**TOWN OF PURCELLVILLE
BOARD OF ARCHITECTURAL REVIEW**

TO: Chairman and Members of the Board of Architectural Review
FROM: Daniel Galindo, AICP
RE: CDA14-04 Southern States Preliminary Review
DATE: April 18, 2014

PROTOTYPE RETAIL FACILITY

SOUTHERN STATES COOPERATIVE, INC.

SHEET TITLE: BUILDING ELEVATIONS PROJECT: PROTOTYPE RETAIL FACILITY SOUTHERN STATES COOPERATIVE, INC.

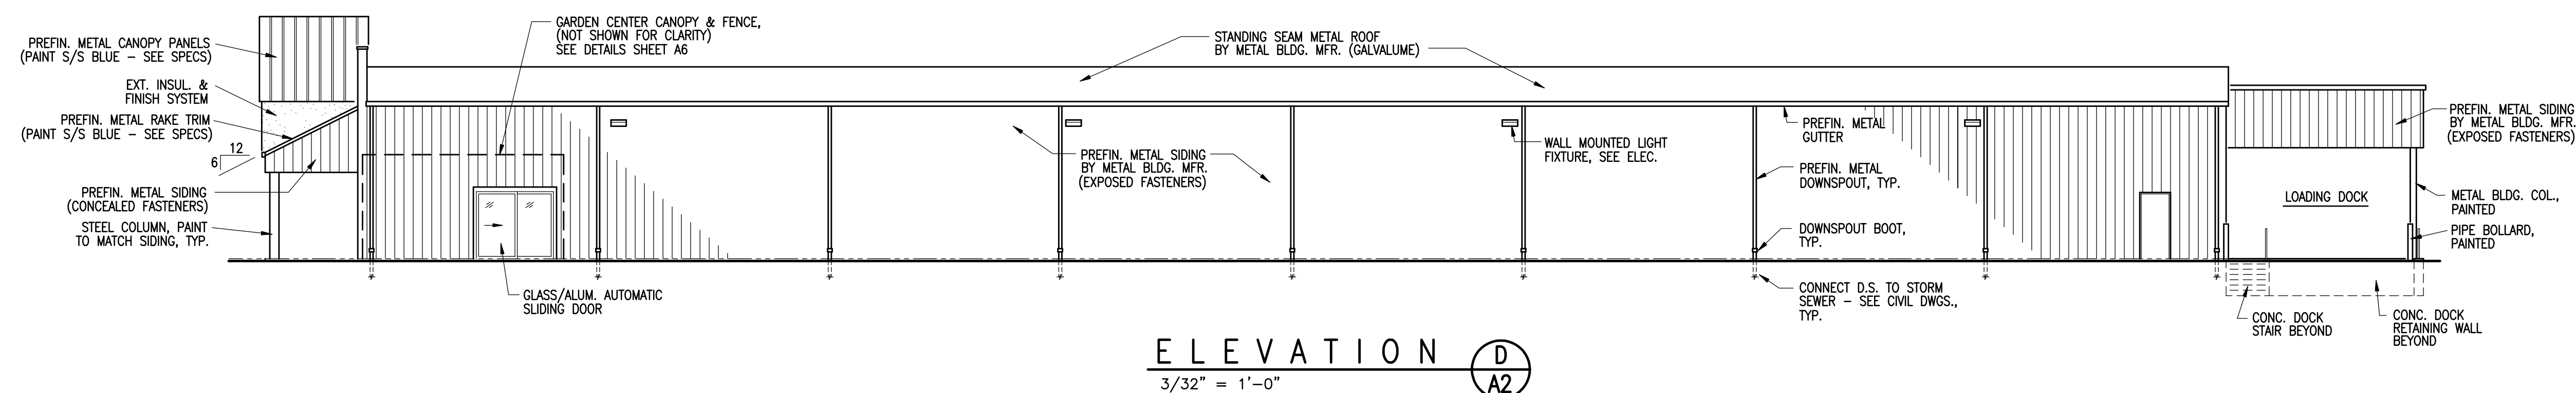
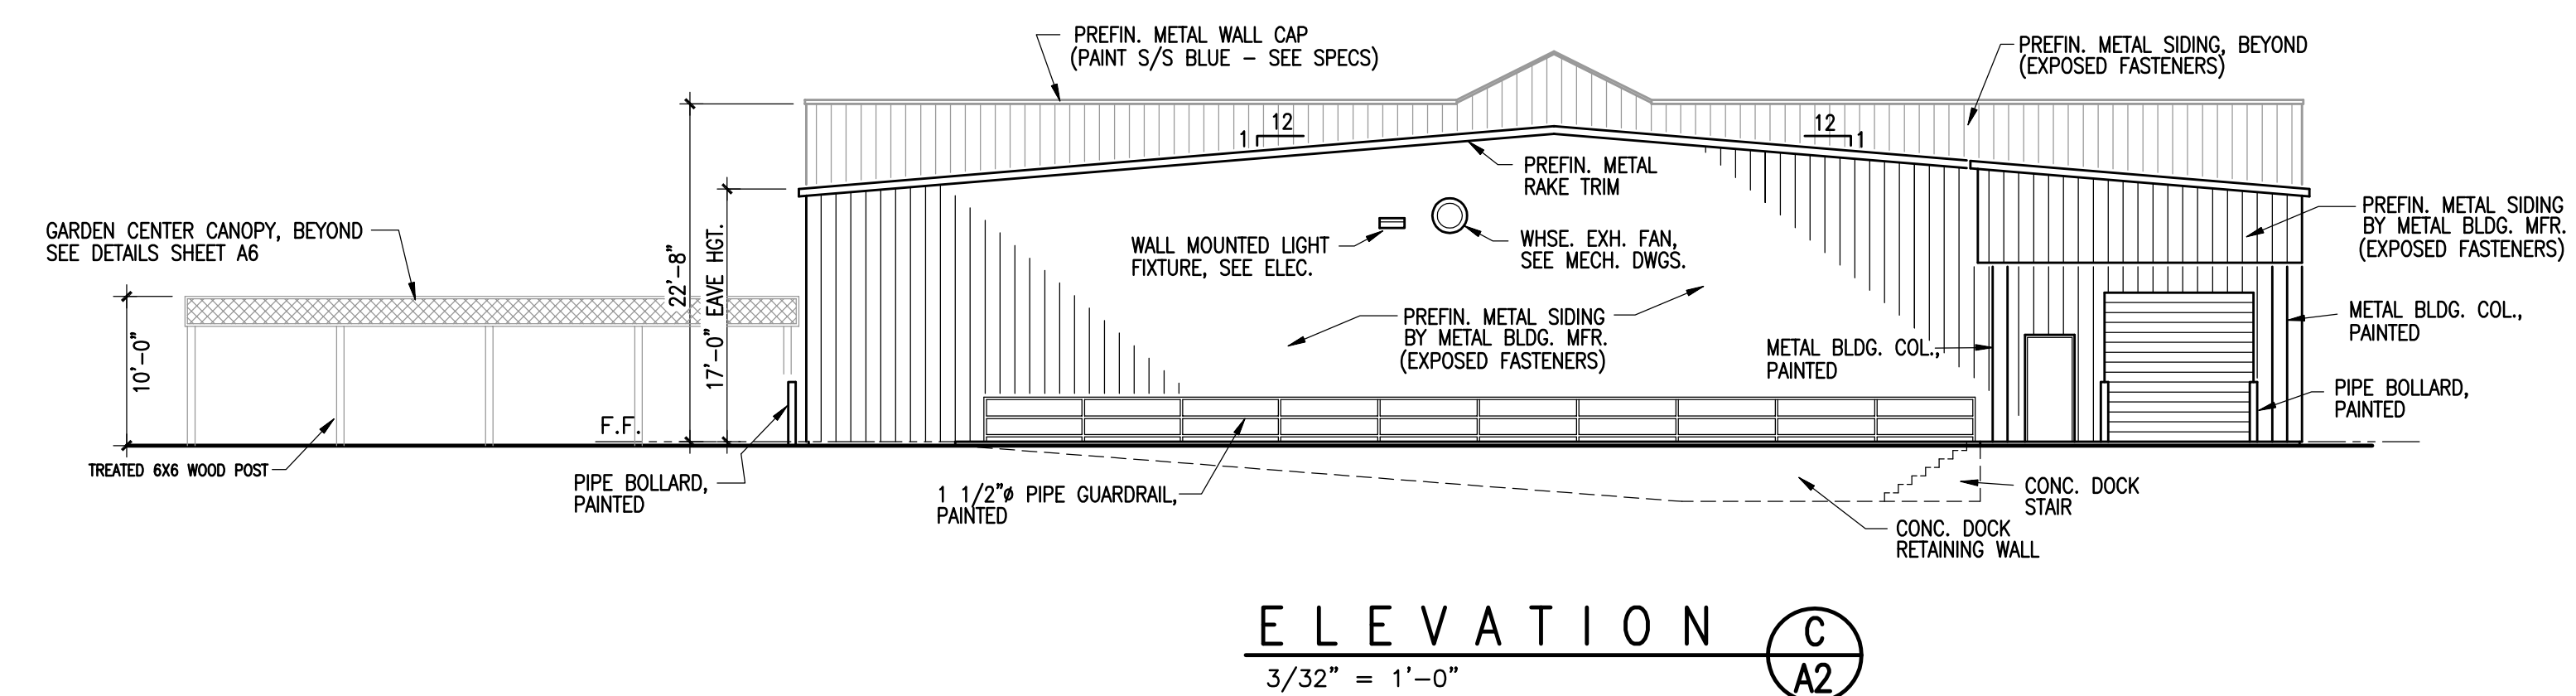
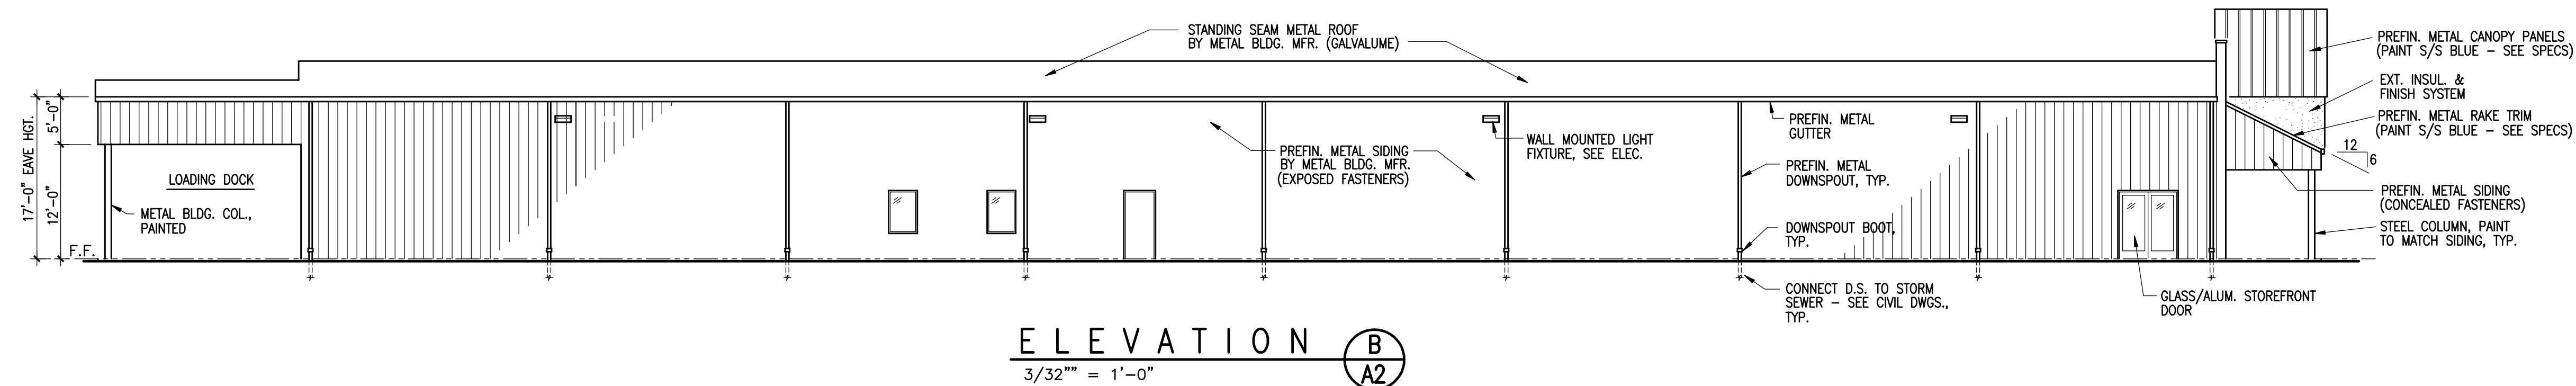
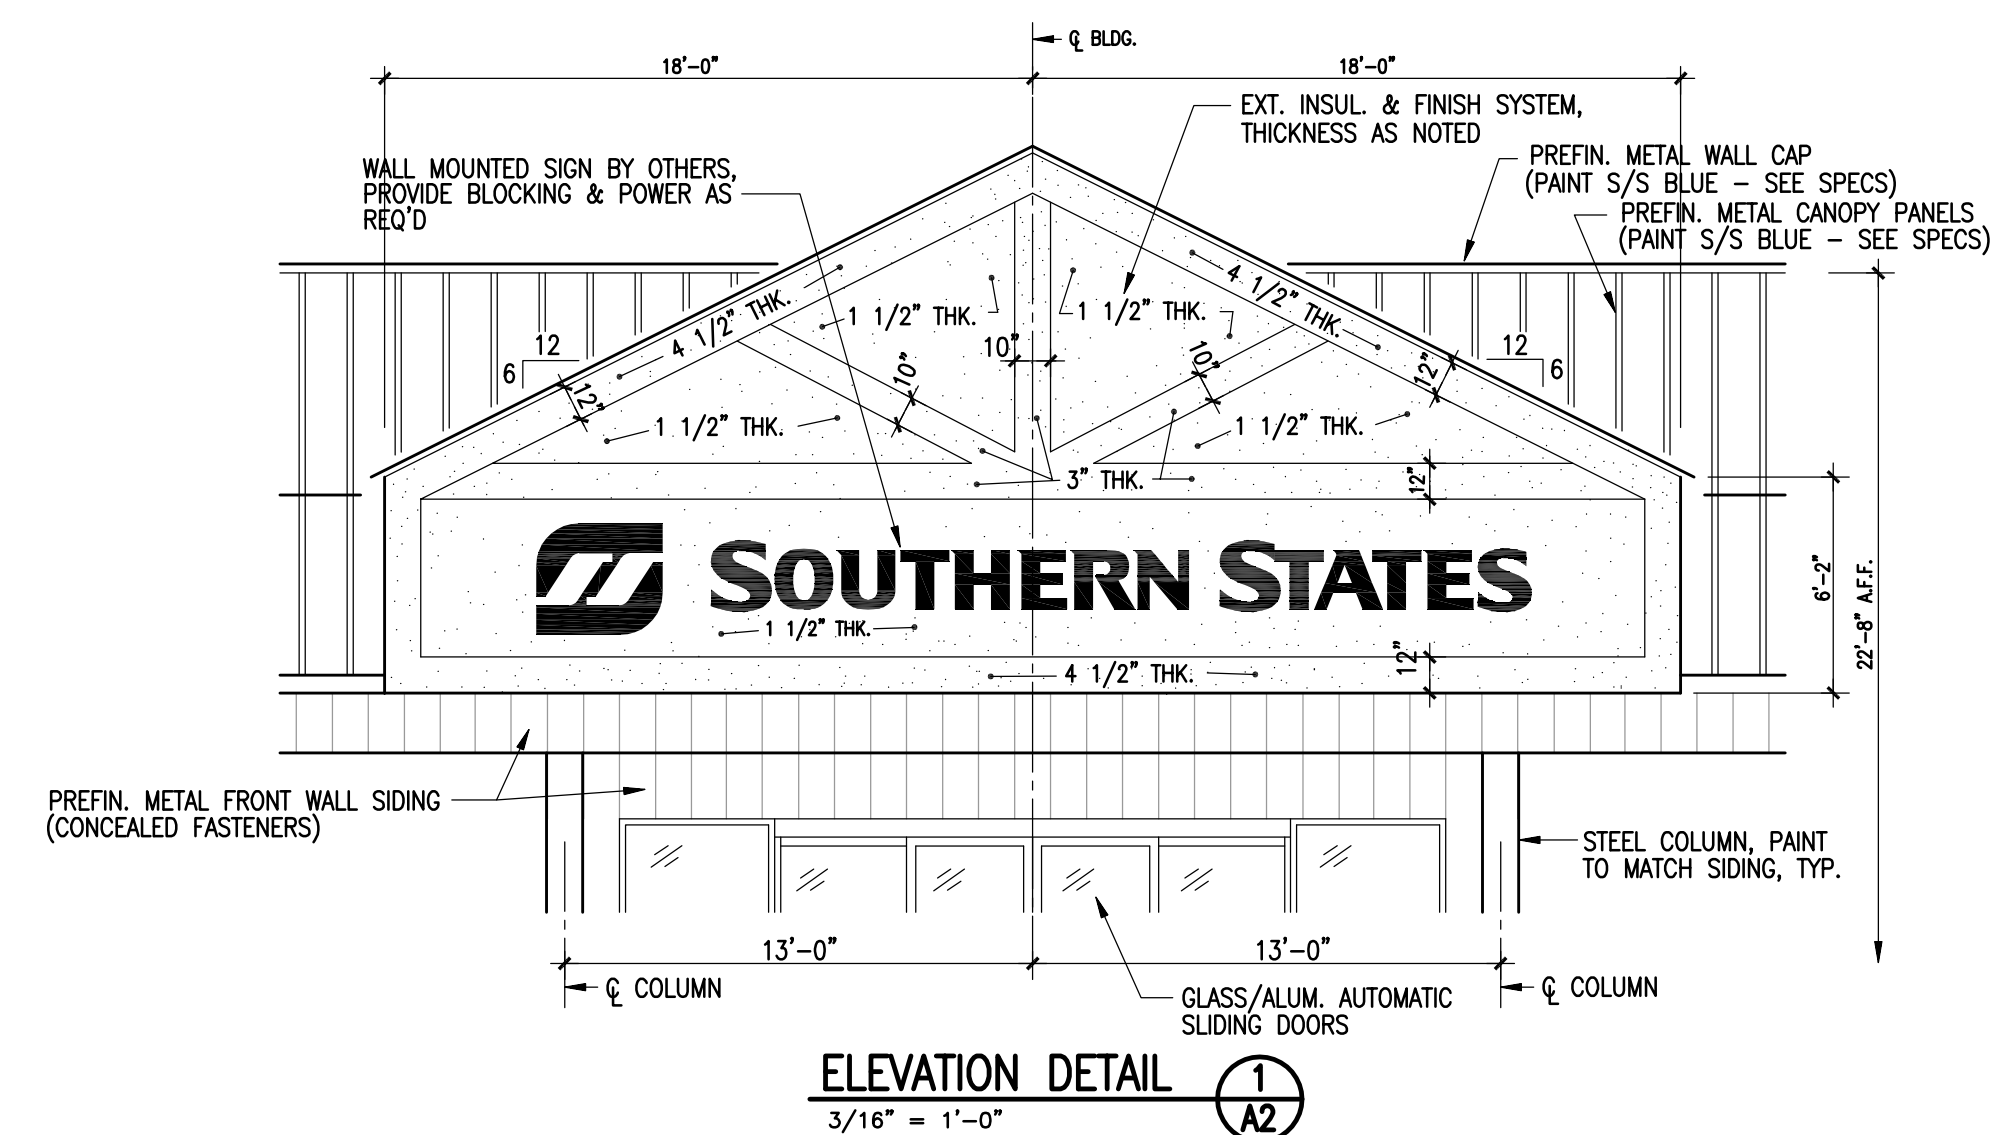
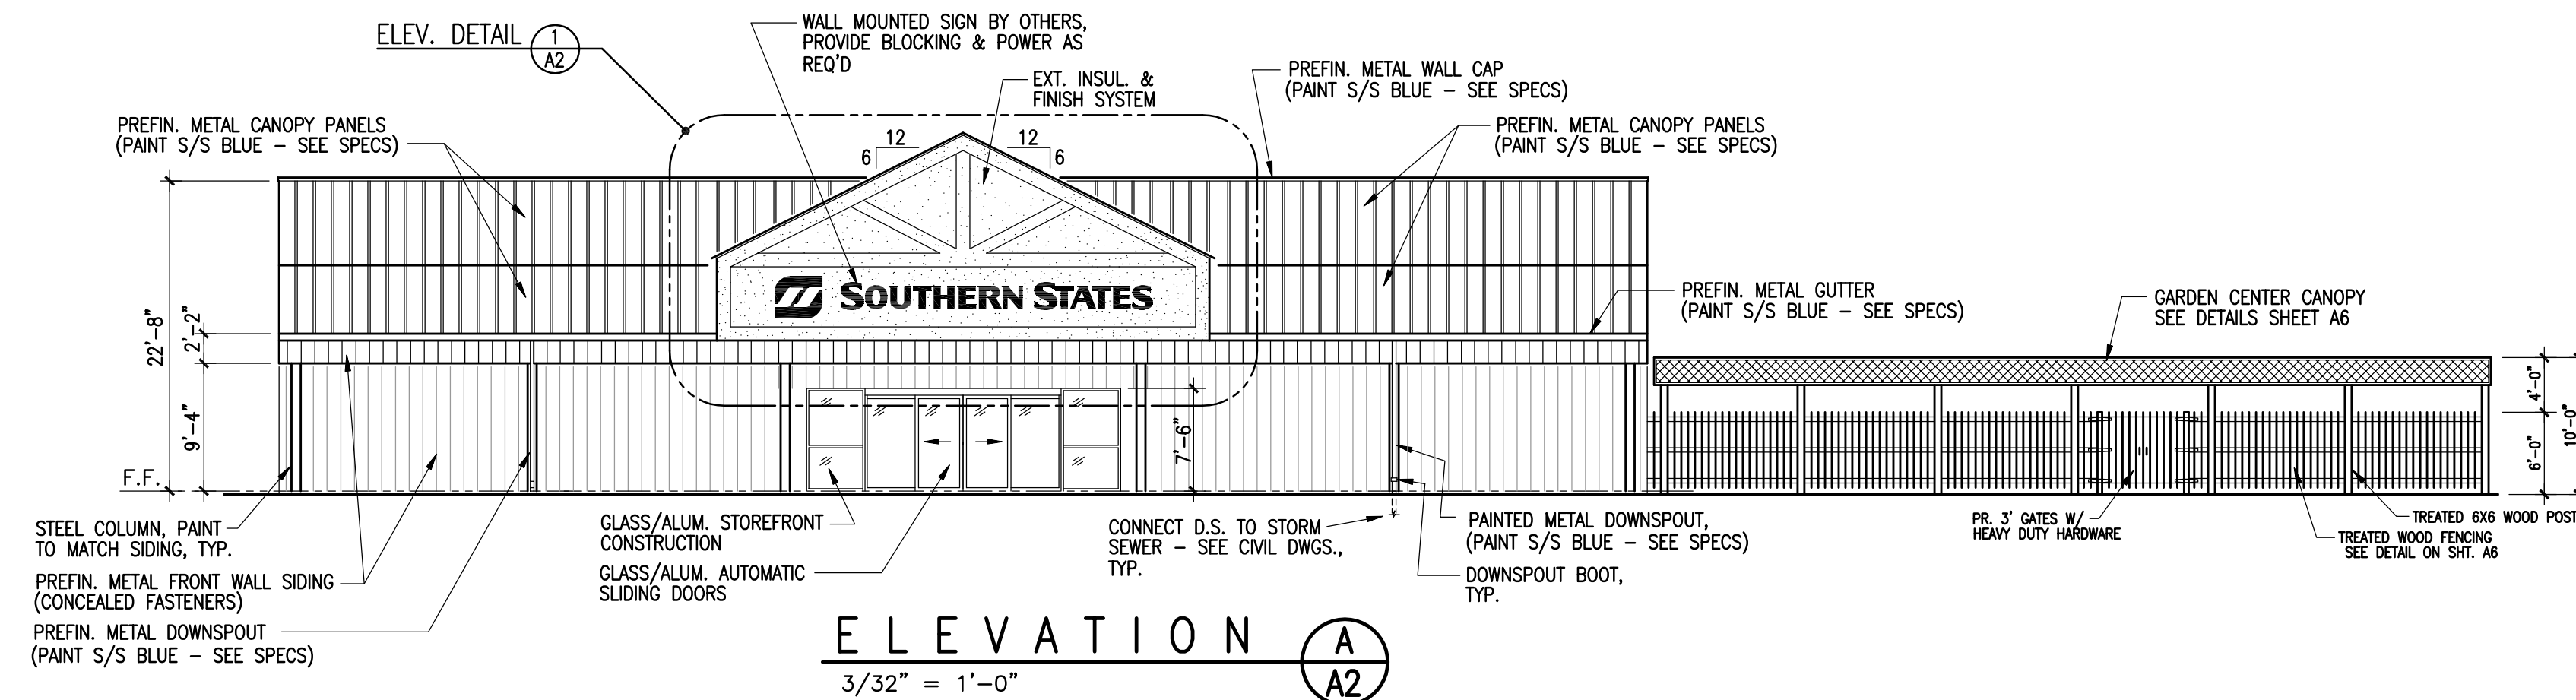
2. The prototype design is largely unarticulated while the Guidelines encourage dividing walls into structural bays, breaking wall façades with vertical and horizontal articulation, and breaking storefront façades with elements that are human scale. (See *Façade Articulation*, pg. 12)

3. Other than the glass used for the entry vestibule, the storefront lacks windows which are encouraged by the Guidelines. Alternatively, the Guidelines recommend "closed in" glass storefront displays when "windows are not desired given the function of the building" (pg. 14).

4. The Guidelines discourage the use of primary colors on façade exteriors (pg. 15) while the metal roof and downspouts along the front façade and gutters for the entire building are proposed as "Southern States Blue." (It is unclear whether the remainder of the roof would utilize the same color.)

5. The proposed windows lack any of the articulations recommended by the Guidelines such as shutters, holdbacks, cornices and sills (pg. 15).
6. Dark bronze aluminum doors and storefront framing are proposed for the building. The Guidelines state a preference for wood over aluminum, but when aluminum is necessary, a pre-finished color is preferred. However, mill and dark bronze finishes are strongly discouraged (pg.17).

8. Exposed steel columns are proposed, but these are not allowed by the Guidelines (pg. 19). (Note that all of the steel columns would be painted.)
9. The proposed columns lack the traditional base and column expression encouraged by the Guidelines (pg. 19).

TITLE		MPW080, MPW120, or MPW 160					
DWG NO. / FILE NO.		MPW080, MPW120, or MPW 160					
DRAWN BY		DAS	DATE	3-6-06	APPR. BY	JEB	DATE
REVISION NO.		XXXX	REVISION DATE	MM/DD/YY	APPR. BY	XXXX	APPR. DATE
Rev. No.		0	6-1-06	MPW080, MPW120, or MPW 160		MM/DD/YY

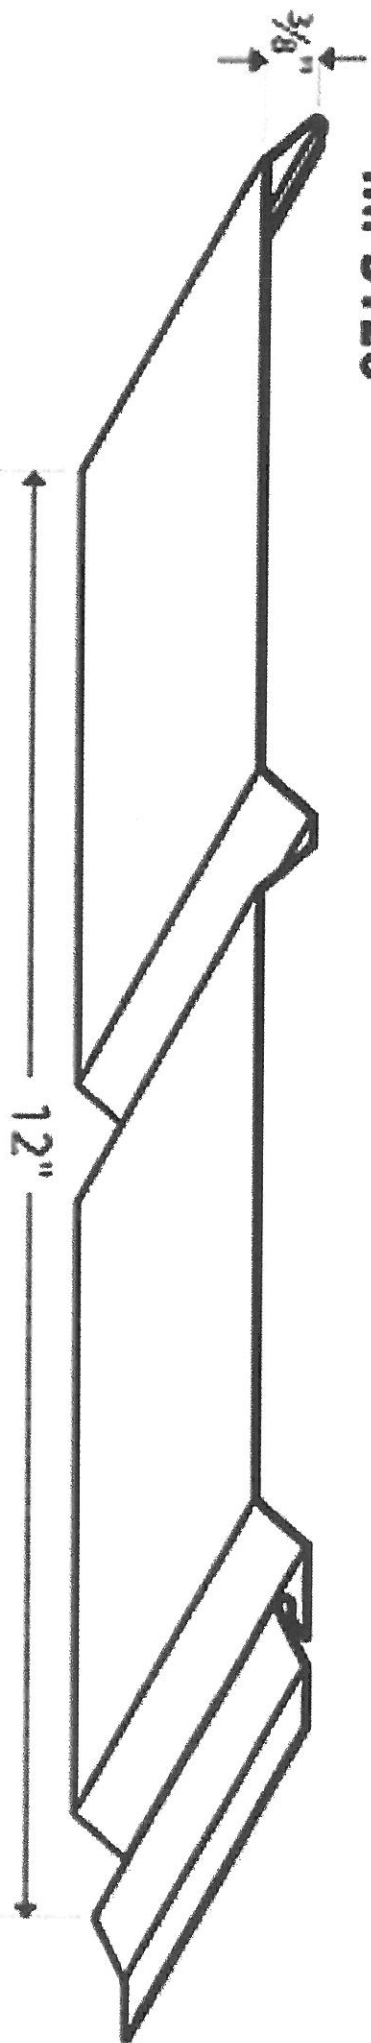
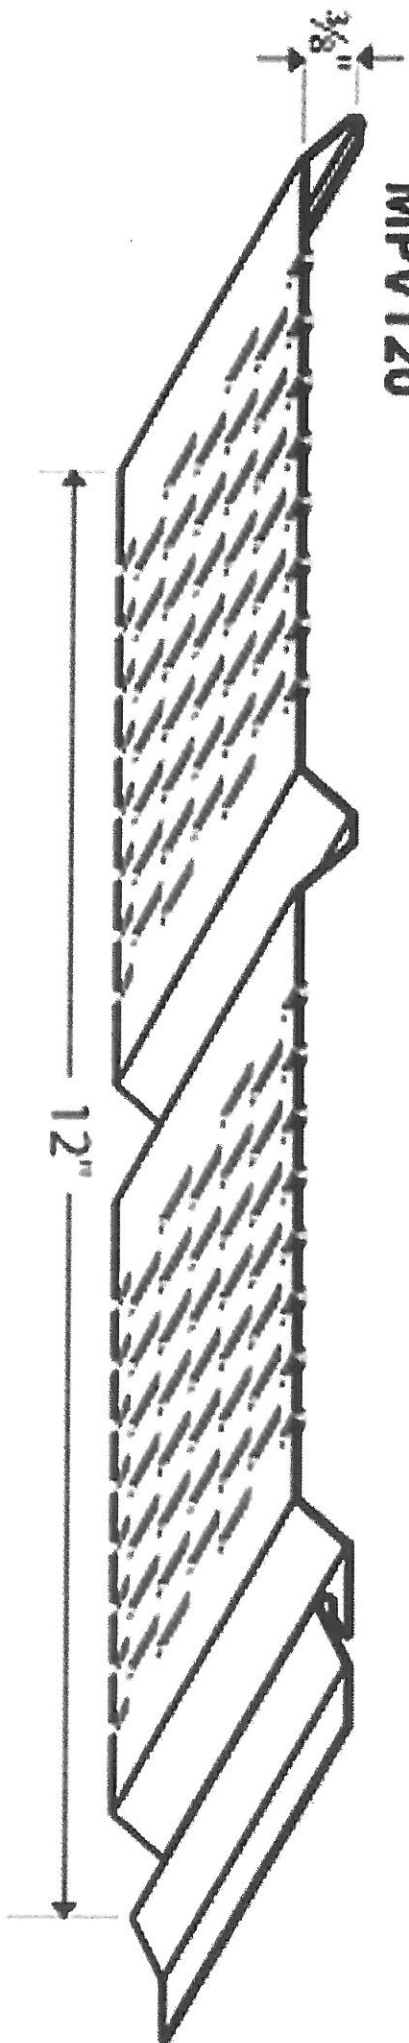
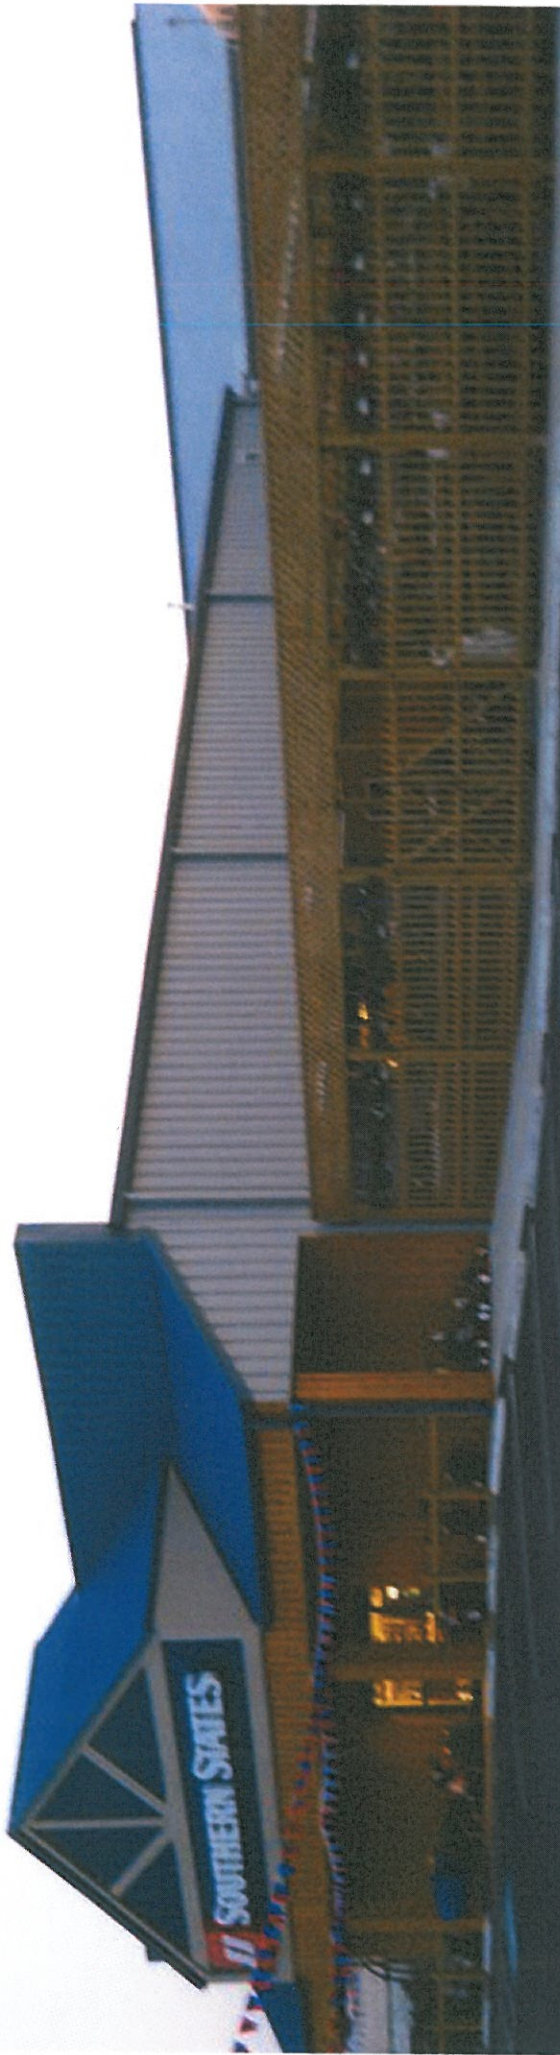
- d. Which tan will be used for the wall panels under the canopy?
The wall panels will be a board and batten style (MPW120 – see cut sheet provided) in the color Rawhide. I will bring a sample of the panel and color to the BAR meeting.
